Alice Gailey, 37 South Hill Park, London NW3 2ST.

Re: Planning Application for 35 South Hill Park, Application Ref. 2014/1938/P

Review of planning application 2014/1938/P to Camden Council with respect to Camden development Policy DP27.

Project Ref. G1406	Project Title. 35 SOUTH HILL PARK NW3	Sheet Ref. FIGURE 1
	UNDRAINED SHEAR STRENGTH vs DEPTH BIA RESULT vs HAMPSTEAD DATA

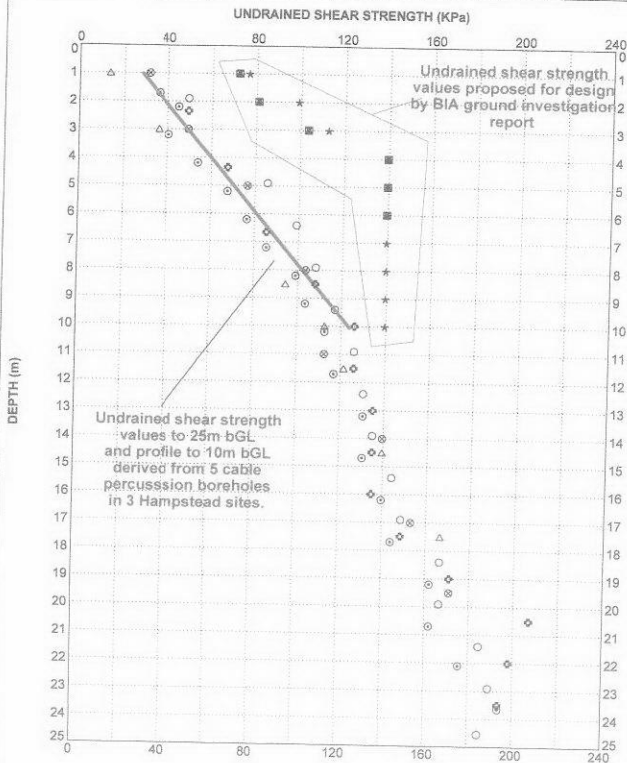
37. These comments are based upon more than 20years experience of conducting ground investigations and operating a soil testing laboratory. They are substantiated by authoritative texts [2]. Figure 1 in Appendix A compares the test results offered by the application with the very consistent results obtained in sites spaced widely over the Hampstead area by different investigators using more reliable methods. The investigation reports concerned are in the public domain. They included investigations of both Unit D of the London Clay and the Claygate Member and demonstrate the well known and expected consistency of the formation.

38. The engineers' method statement relies upon the site tests made and reported by Ecologia. A safe foundation bearing pressure of 150KPa has been assumed for design. In consequence of this comparison on Figure 1 and of experience of other local sites, I believe that the engineers' assumption seriously overestimates the ground strength to a degree that affects the preliminary design adequacy.

Project Ref. G1406	Project Title 35 SOUTH HILL PARK NW3	Indicative North
Sheet Ref. FIGURE 2	ALLEY WAY JUNCTION OF Nos 35 AND 37

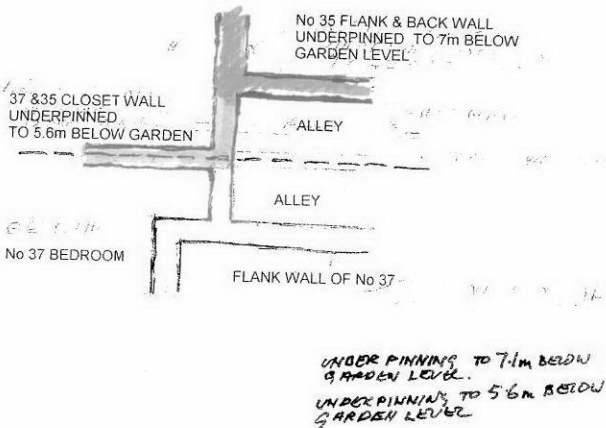
58. The extremely simplistic model proposed by Burland [3] might suffice for some parts of No 37 but would not be suitable for the much more complex situation shown by Figure 2 of the appendix. There, it is fairly certain that without a change of design, significant local damage at the junction of Nos 35 and 37 could result.

PLAN AT JUNCTION
END OF ALLEY WAY
BETWEEN No 35 AND No 37 S.H.P

NO. 35 PROPOSED REAR
DRAWING (1)201

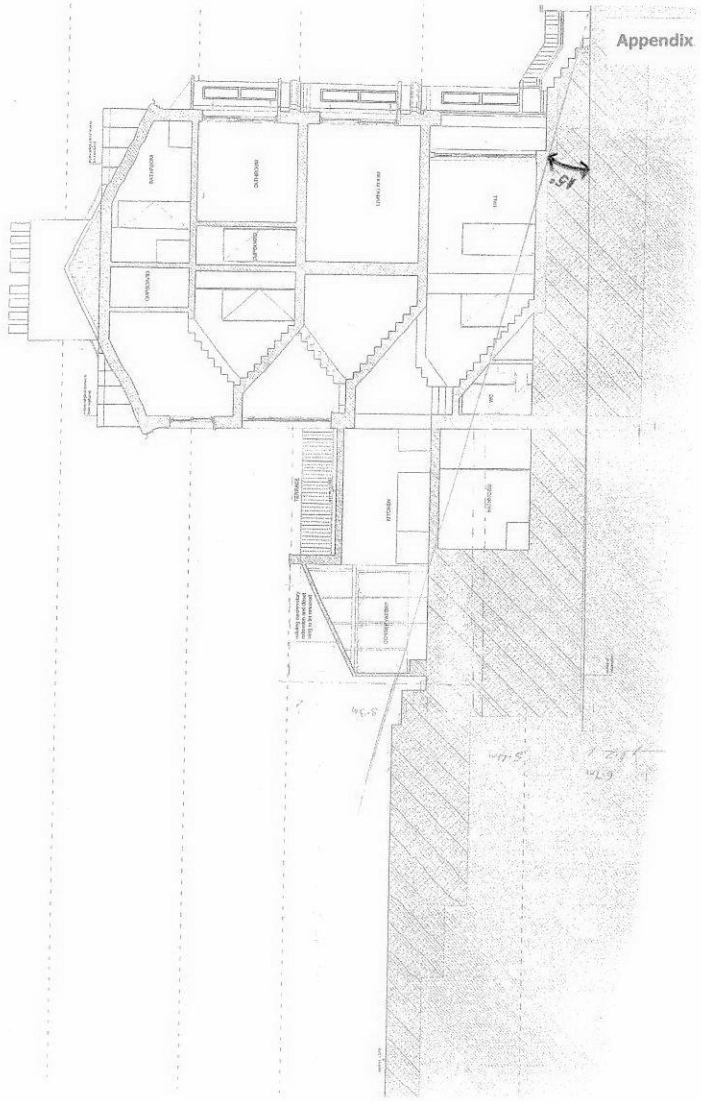
2.1.1.2. The proposed extension on the rear of the existing building does not comply with guidelines for rear extensions/conservatories SHP18. It is 2 stories high, (7m) and varies. It is across the whole width of the house,(6.8m). It protrudes from the rear of the house by 6.8m. This will make it the deepest proposed rear extension at garden level in South Hill Park. It is now less obtrusive, but still adversely affects the character of the building and the conservation area.

2.1.1.5. The proposal is to construct a subterranean room 5m below the existing garden level, with another room varying in height over it, across the whole area at the rear. It is one and a half basements below the existing ground level at the rear. The subterranean room now projects 6.8m, and the room above 6.8m from the rear main building line. The elevation facing the rear will be totally in glass. **This is considered to alter the balance and harmony of a property by insensitive scale, design and use of glass and therefore harm the appearance of the CA and so adversely affect the architectural integrity of the building to which it is attached, so that the character of the CA is prejudiced.**

Photo 1

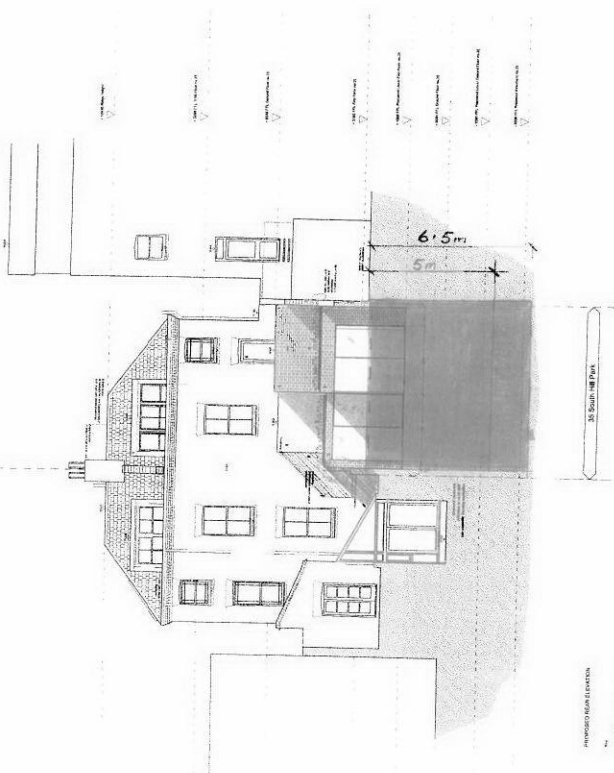
1a). The scheme does not demonstrate that it will maintain the structural stability of the neighbouring building at 37 SHP, as required by Camden Development policy DP27a. This is clearly stated in the summary to his report by Dr M. de Freitas. This is not a matter that can be covered by conditions in a planning permission, but will need to be properly evaluated before one is given. (Para 2.5 Dr M de Freitas report Appendix 1a). See photos 1 and 2.

Shoring up a cracked bay adjoining a property with a recently completed new basement and swimming pool at no94 South Hill Park.

Photo 2

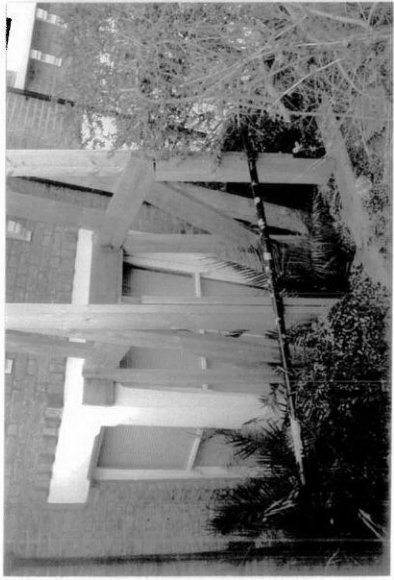
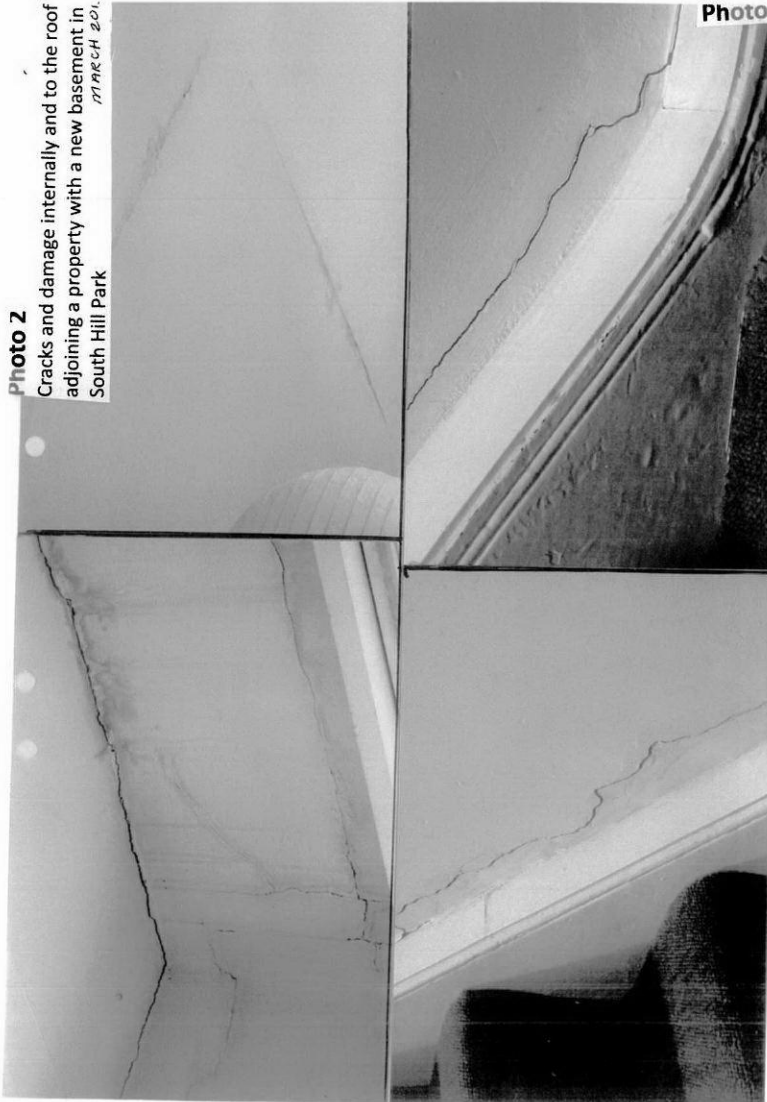
Cracks and damage internally and to the roof
adjoining a property with a new basement in
South Hill Park
MARCH 201

PHOTO 4

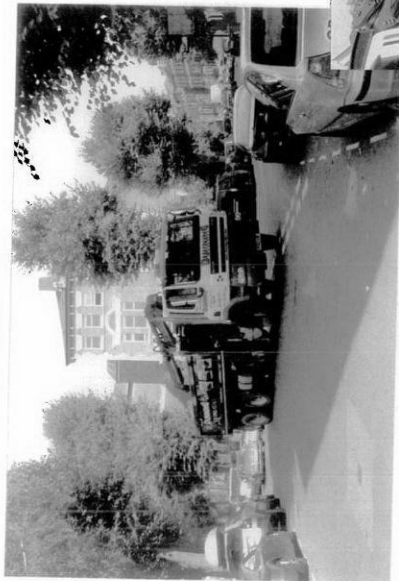
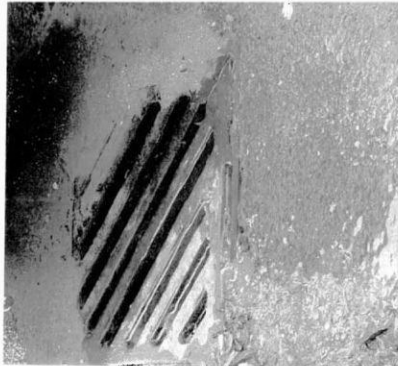
1.d). **The proposal will harm the amenity of neighbours.** The excavation will be around 600cubic metres and this will increase to an extra 300cubic metres for No.33. The volume will increase by 50% when removed and will require HGV's, which turn outside No. 37, in this cul-de-sac and vibrate the house and create noise pollution, destroy the roads. Photos No. 3 and 4.

View up South Hill Park towards no1 and 2 SHP Gardens. An HGV turning back up to no 47. As one leaves another arrives.
